Access Compliance Report Public Rights-of-Way (Pedestrian Signals)

Main Street: **HOLT_AVE** Cross Street: **IRVINE_BLVD** Location: **NE**

ADA ID: **SGRK211011142450** Signal Type: **One Push Button-APS** Overall Compliance: **No** Severity Scores: **BTN 1: 25** **BTN 2: N/A** **No BTN: N/A**

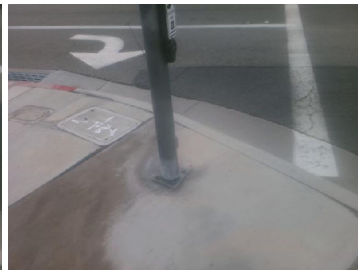
OC Std/PROW: **R404.2, R404.3**

Possible Solutions: Remove and Replace Clear Space.
